## COLORADO RIVER FRONT WORK & LEVEE SYSTEM

ENVIRONMENTAL ASSESSMENT  
COLORADO RIVER FRONT WORK AND LEVEE SYSTEM

June 1983

APPENDIX E - Letters of Comment on the July 1981, Draft Environmental  
Assessment and Bureau Responses to those Letters of Comment

AUGUST 22, 1980  
 SHEET 7 OF 11

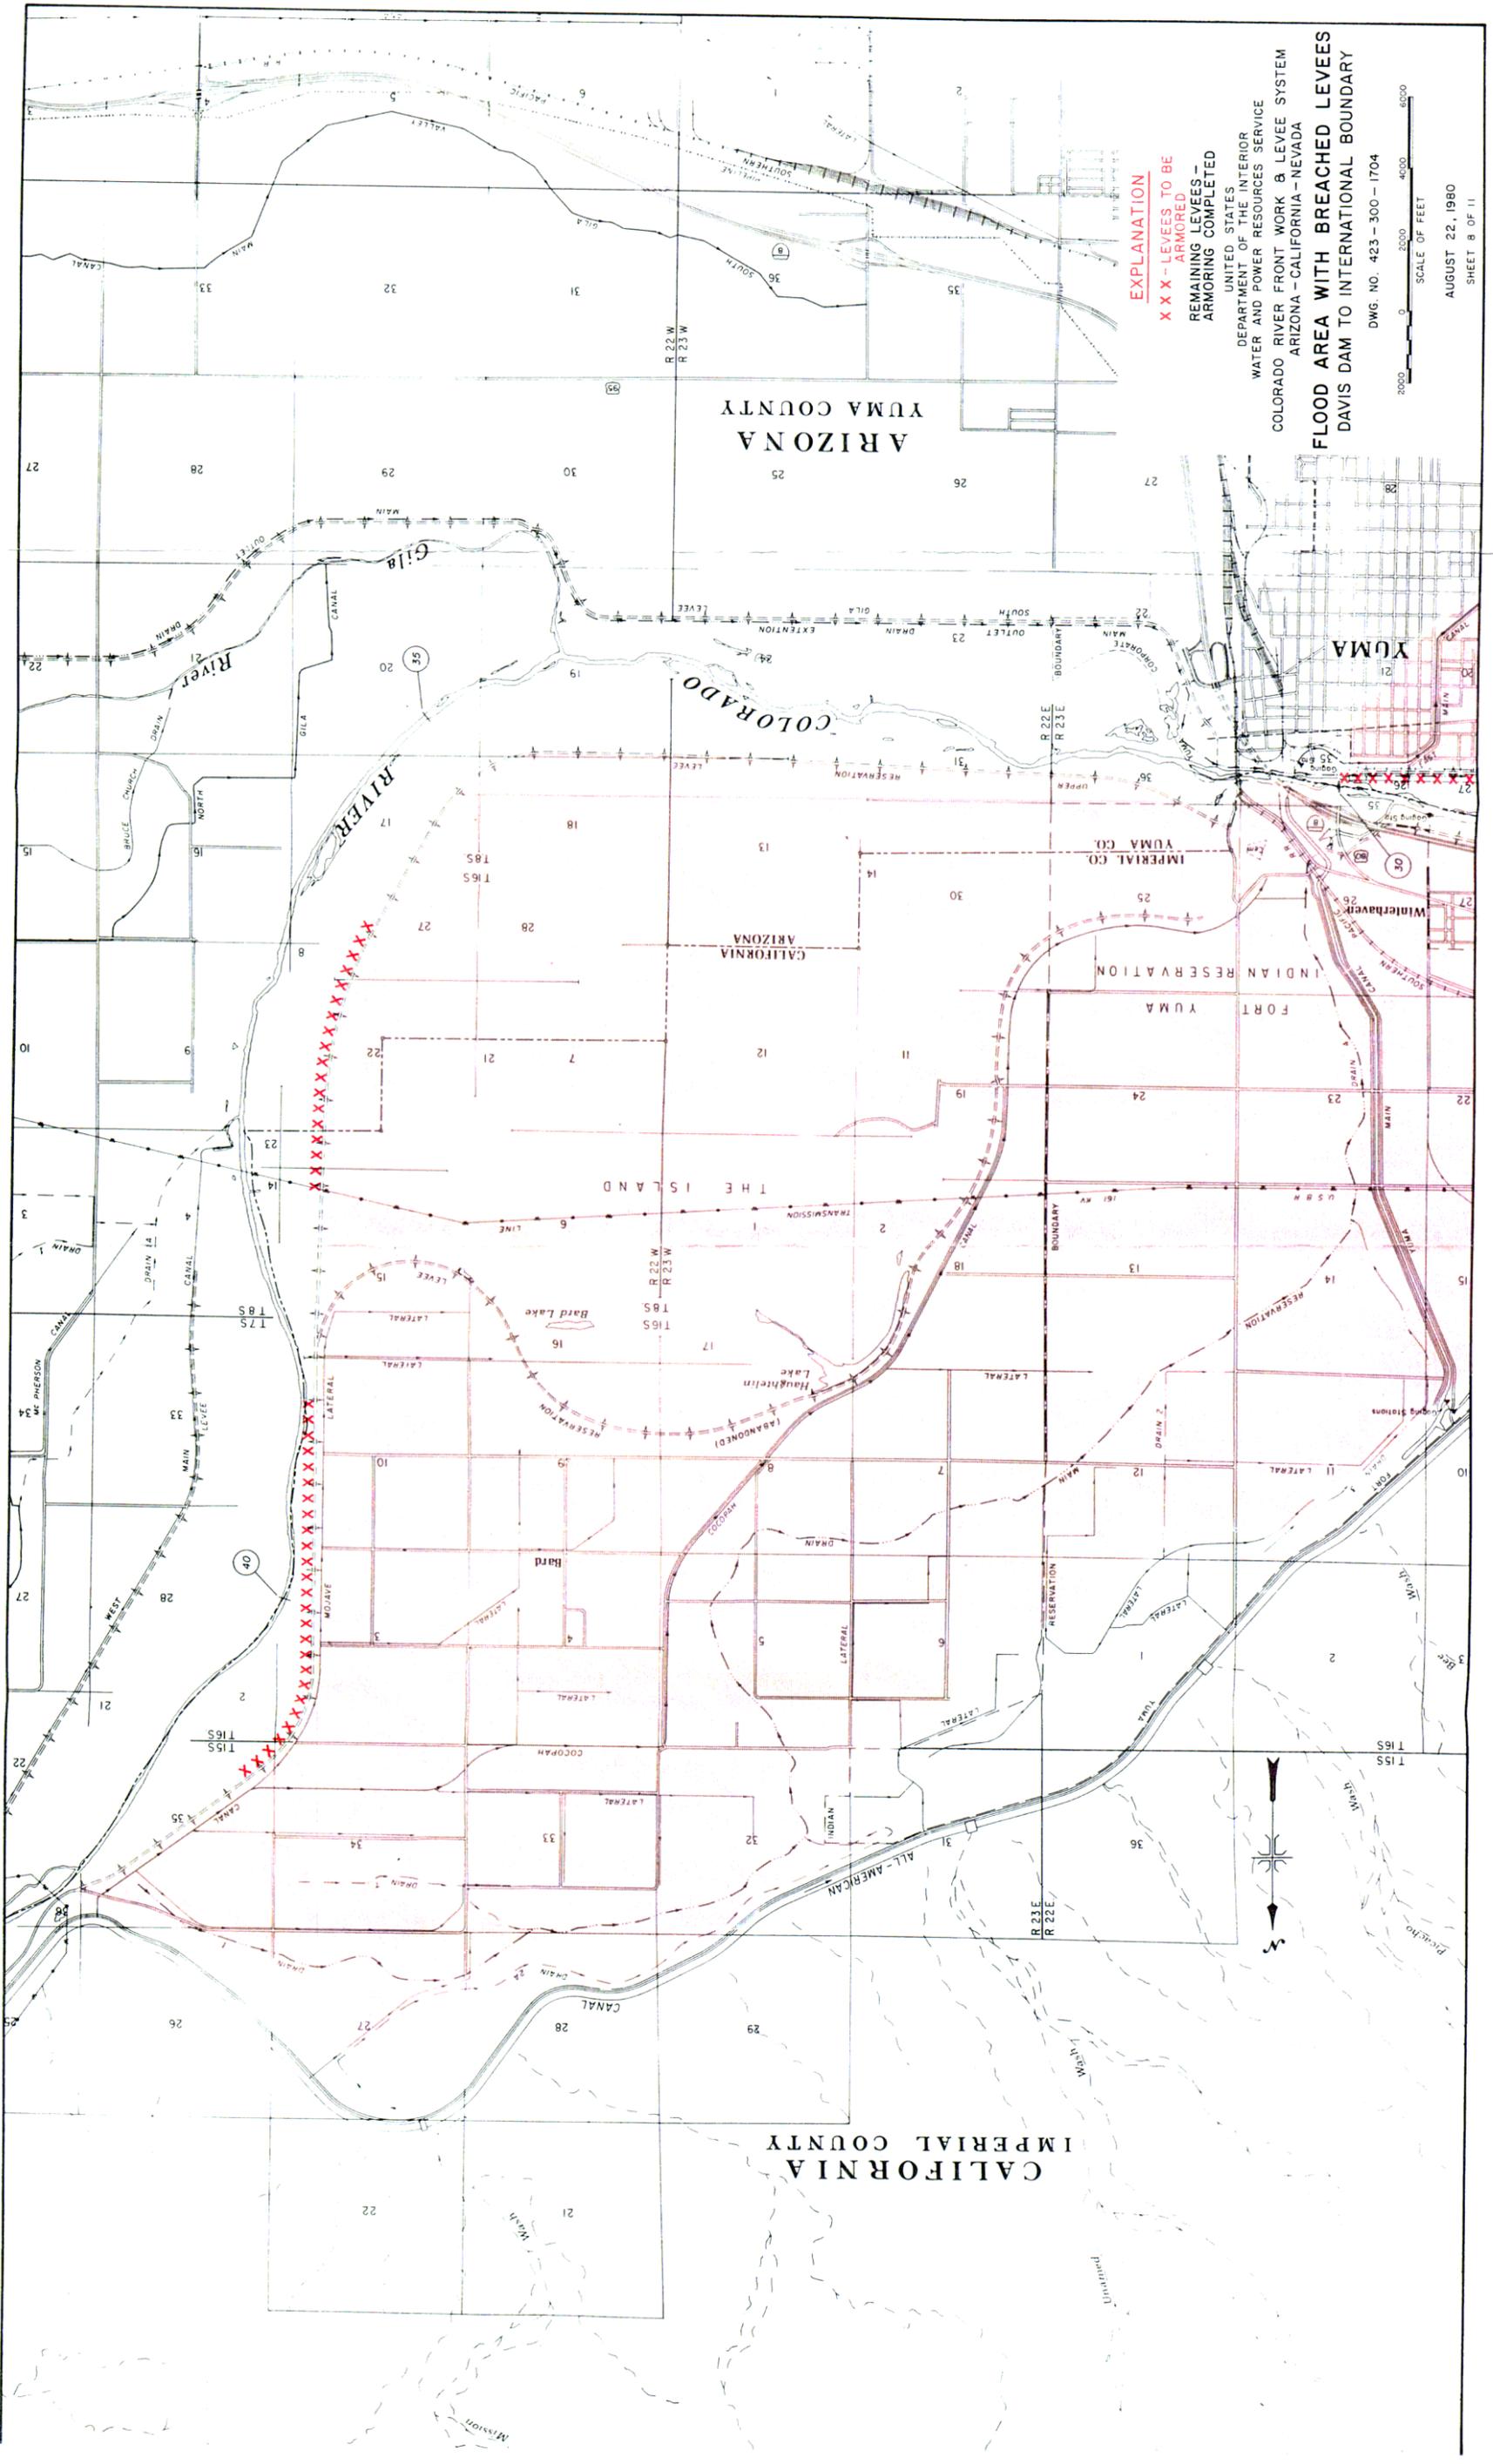
Paymaster Landing and Walter's Camp are erroneously labeled on Sheet 7 of the Flood Area with Breached Levees map. This error has been carried over from the USGS 7.5' maps.
